03	24/05/2022	JC	GR	See note in revision cloud
02	18/03/2022	JC	GR	See note in revision cloud
01	05/07/2021	GR	TK	See note in revision cloud
-	28/05/2019	GR	SK	First Issue

PROJECT STATUS	Riba Stage 5
CLIENT	Manchester City Council
PROJECT	Our Town Hall
DRAWING TITLE	Chimney Number CS33 proposed repair
SIZE & SCALE	A2: As indicated
DRAWING STATUS	S4 - Construction
JOB NUMBER	236959
DRAWING NO.	OTH-PUR-TH-RF-DWG-A-4194 03
REV

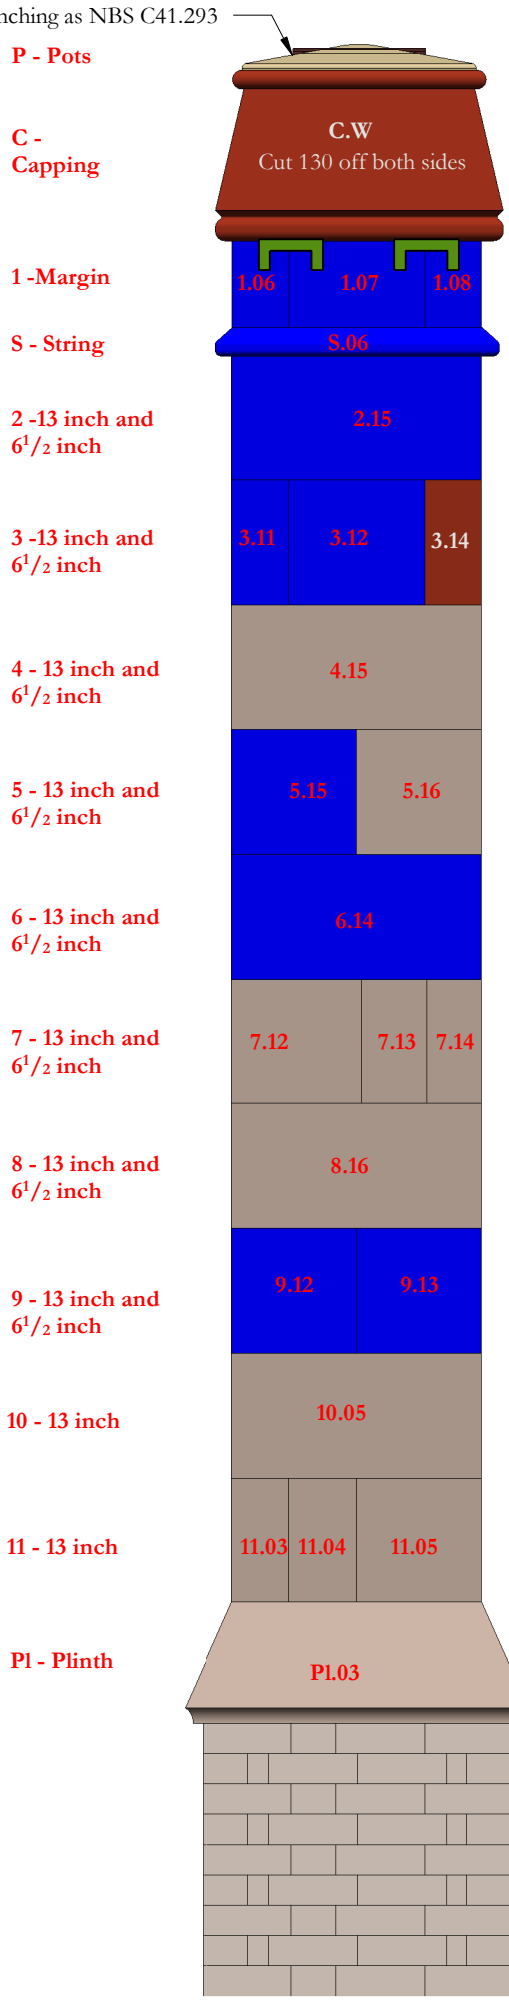
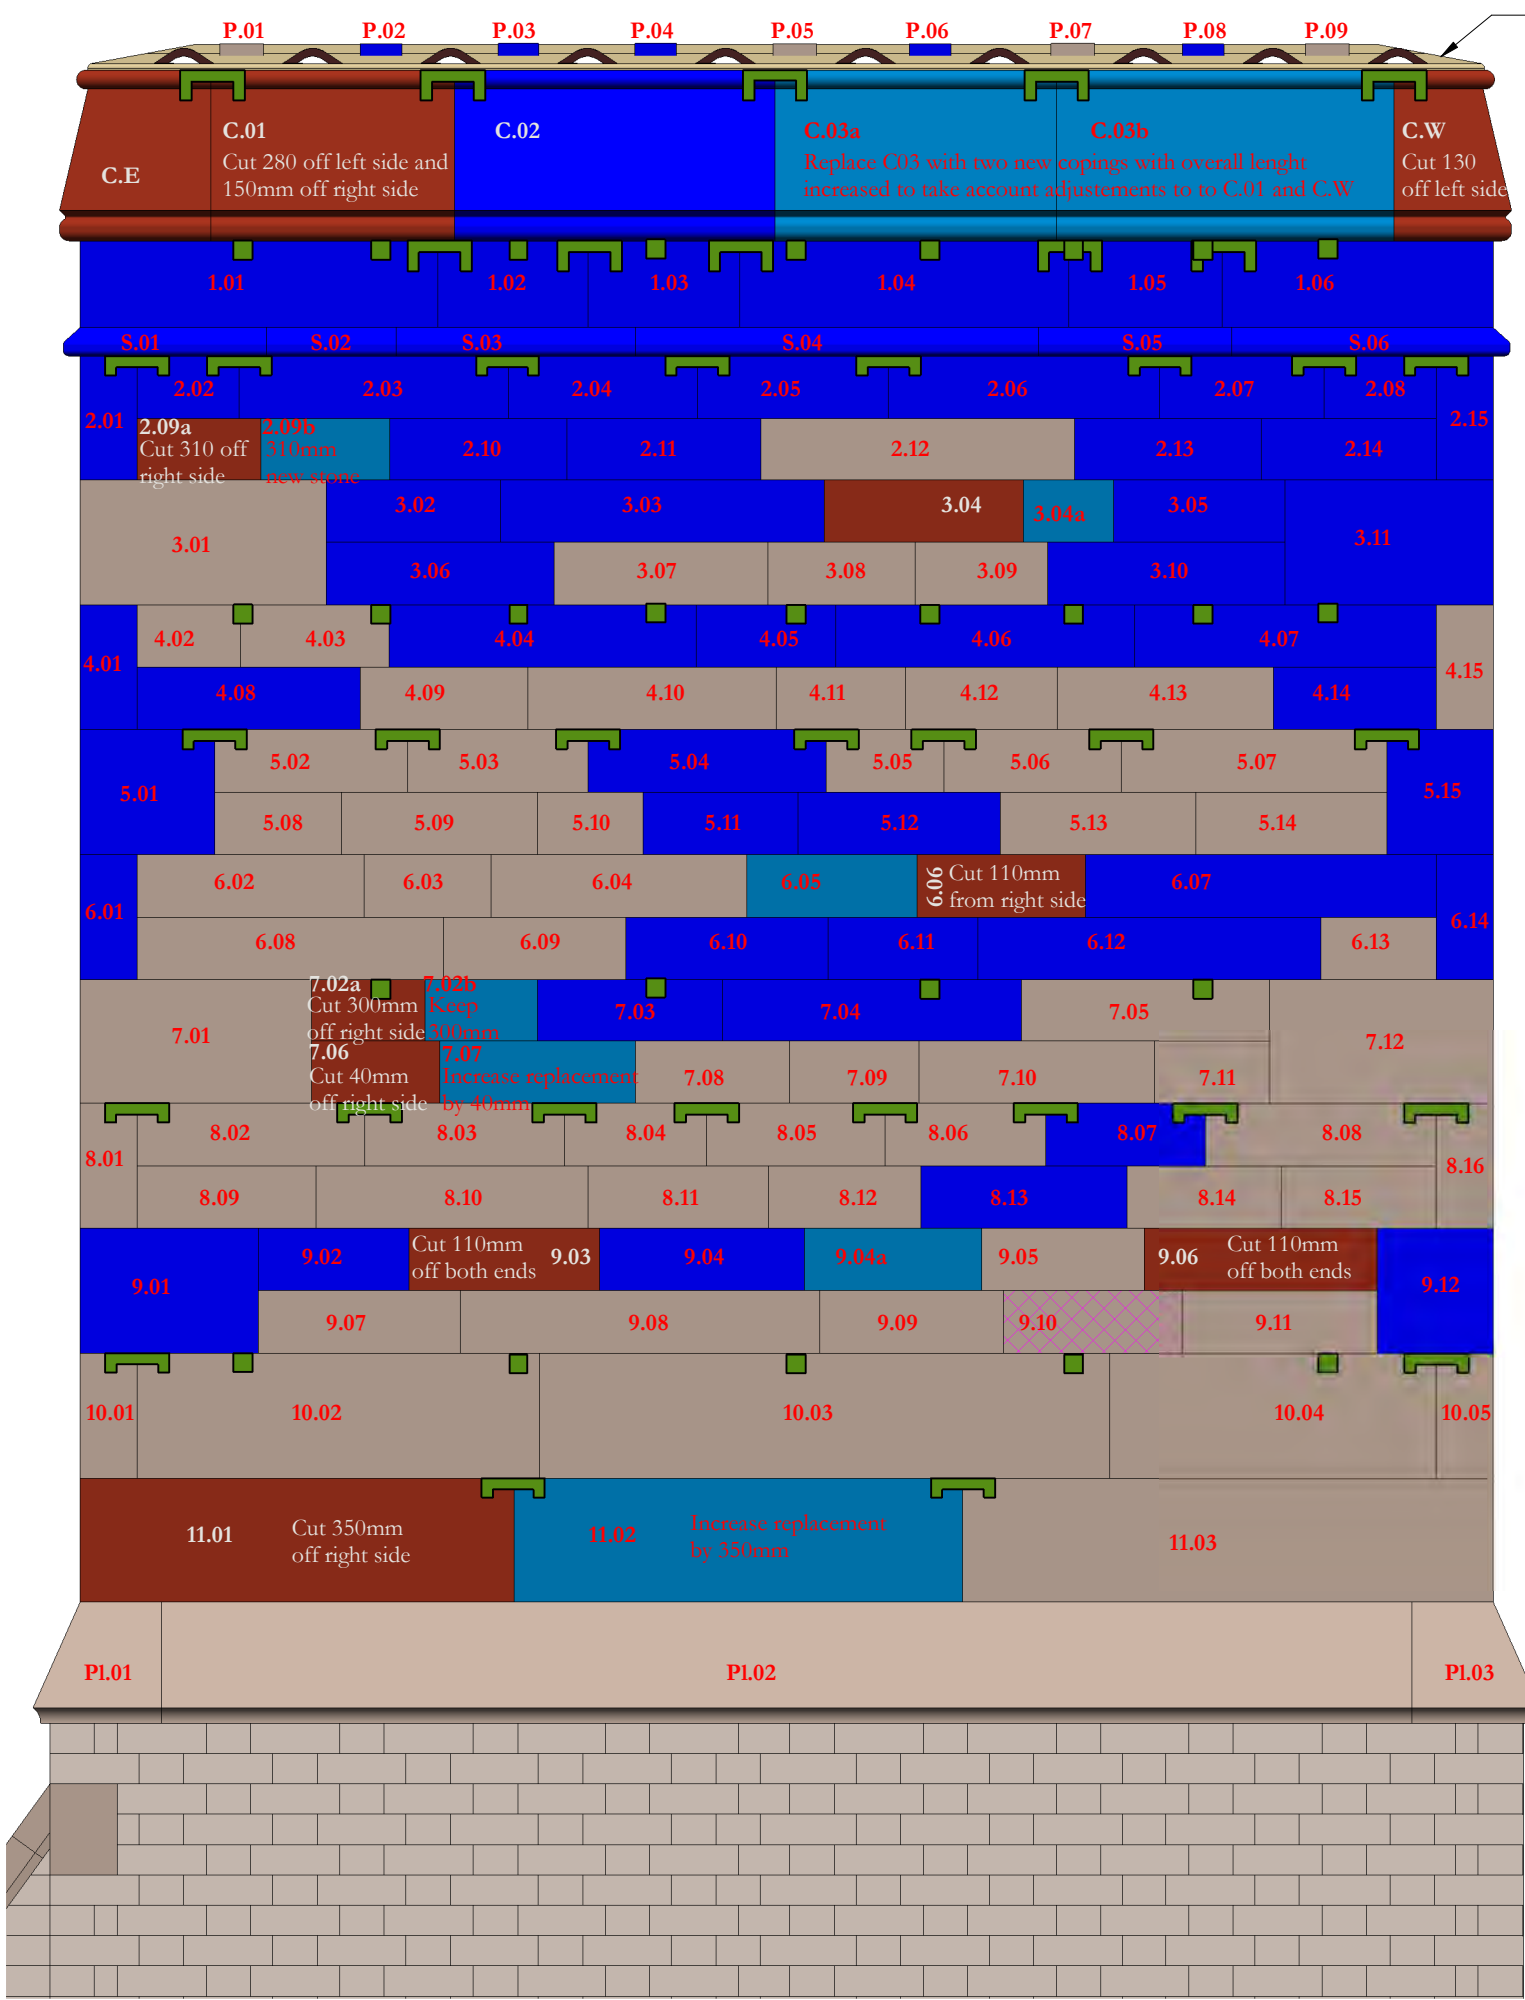
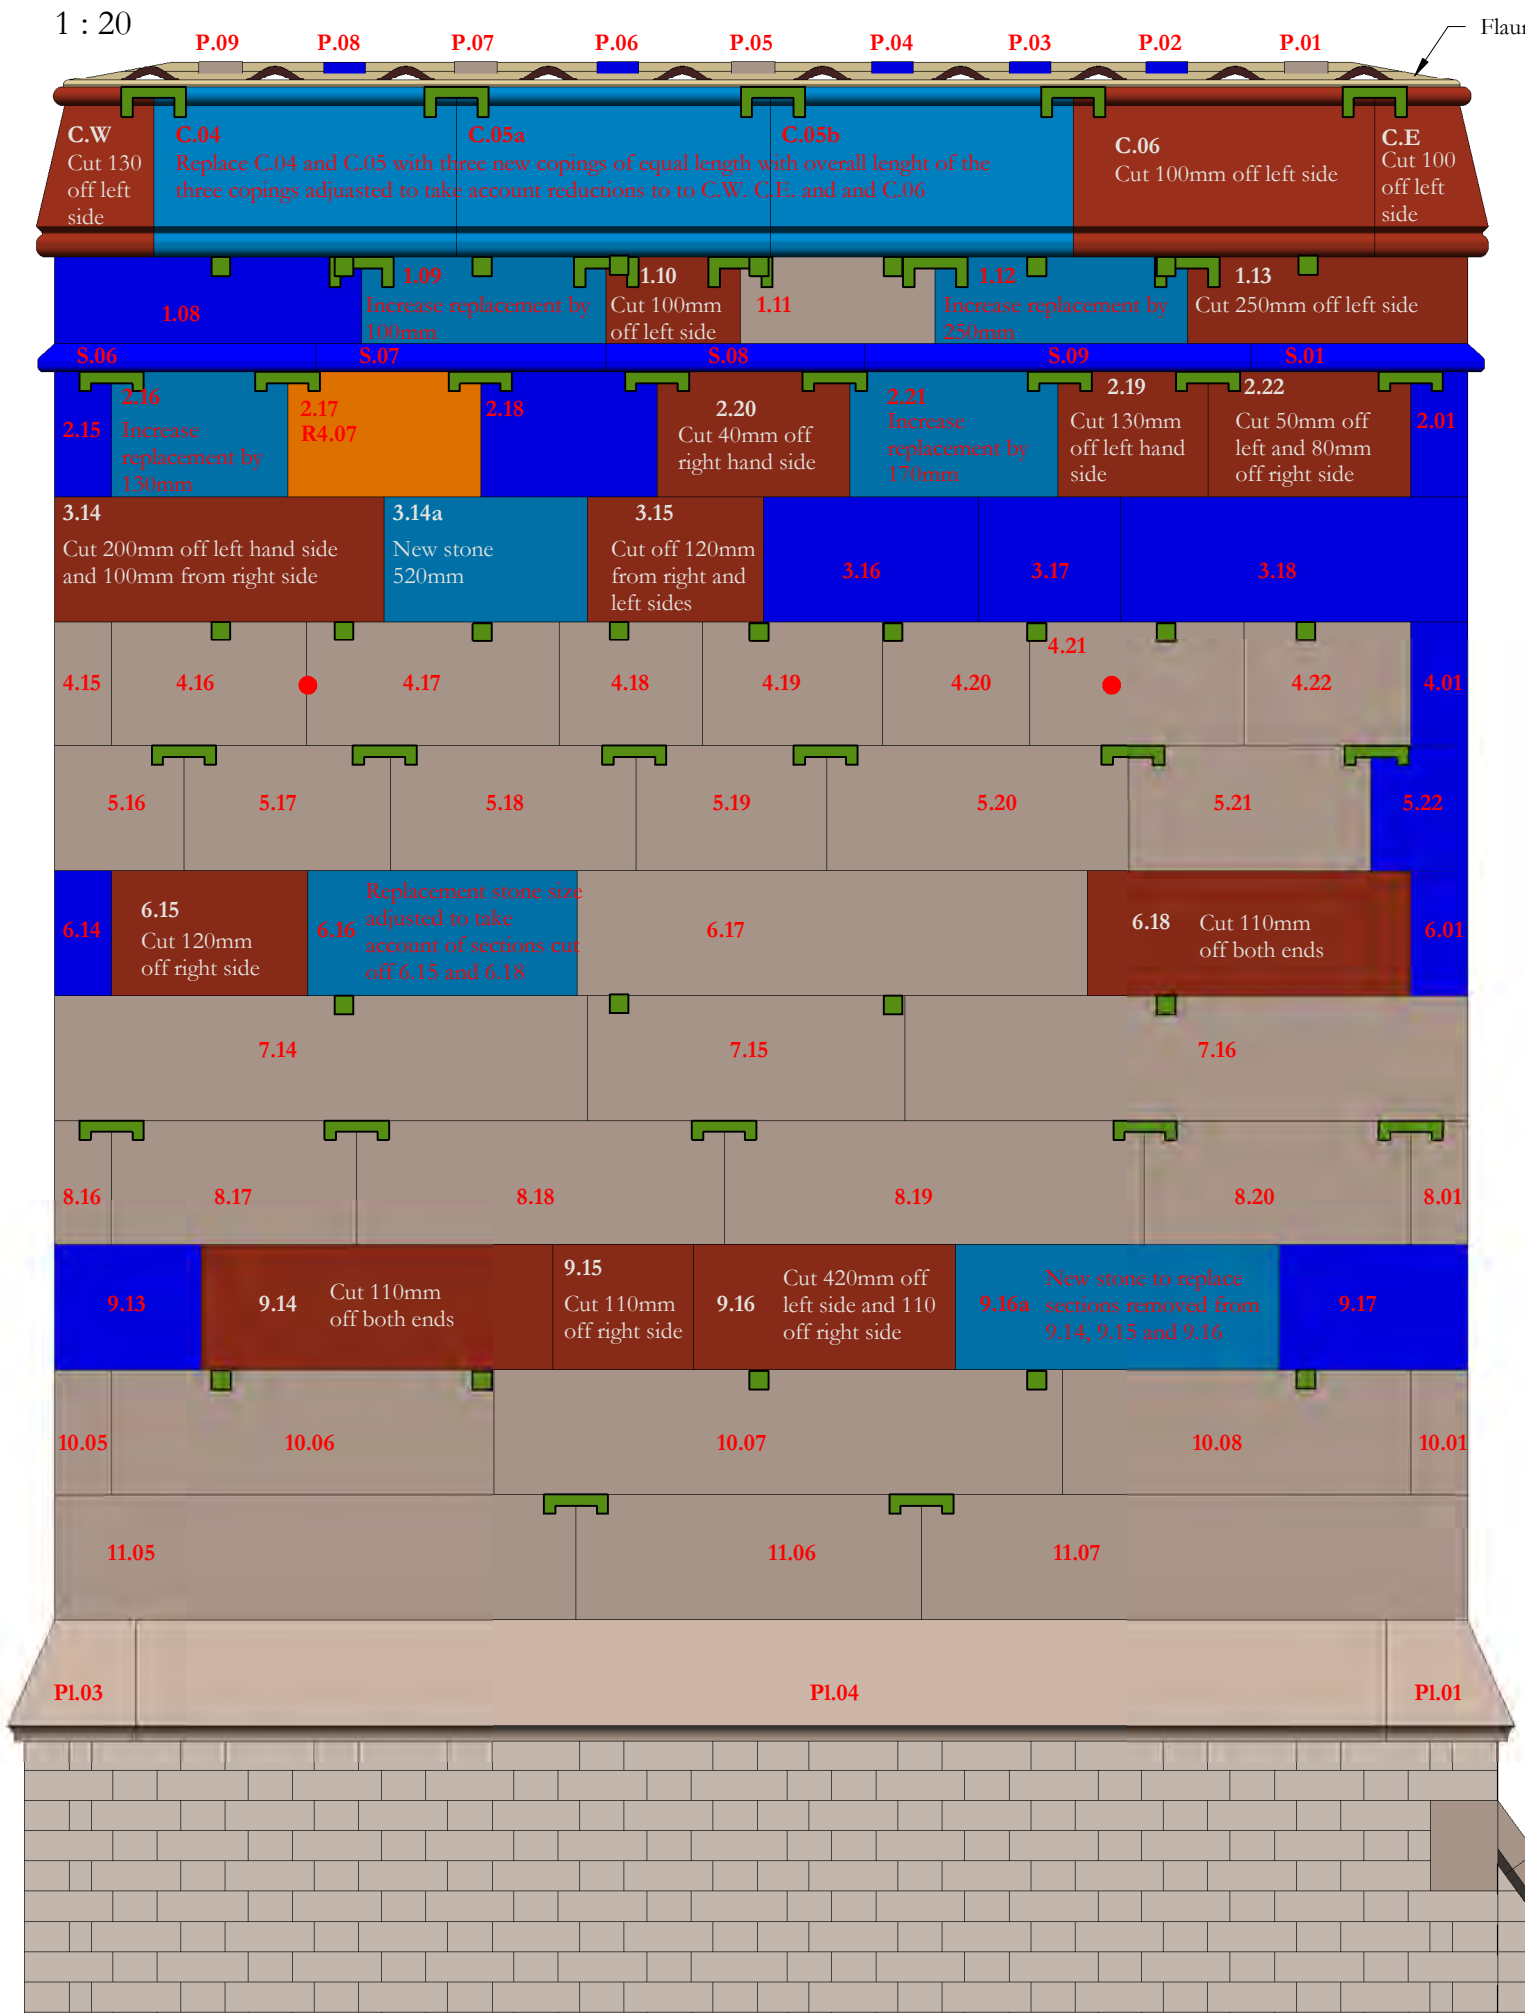
Revision 03: Damaged sections to be removed from ends of stones 6.15, 6.18, 9.03, 9.06, 9.14, 9.15 and 9.16. Replacement stones 6.01, 6.05, 6.16, 9.04 and 11.02 added. Replacement stones 5.16, 7.01, 7.16, 7.12 and 11.05 omitted, existing stones to be reused

Revision 02: Stone copings C.02, C.04 and C.05 to be replaced instead of adjusted. String course stones S.01 and S.05 gained to complete replacement. Stone 2.17 to be replaced with reclaimed section of stone 4.01. Stone 3.04 to be cut down to remove damaged section and new stone 3.04a added. Stones 3.11, 3.12, 4.01 and 5.15 to be replaced. Additional damage to be cut off stones 3.14 and 3.15 and new stone 3.14a introduced. Cross feather cramps added in courses 4, 7 and 10 and stone to stone cramps added in courses 5, 8 and 11
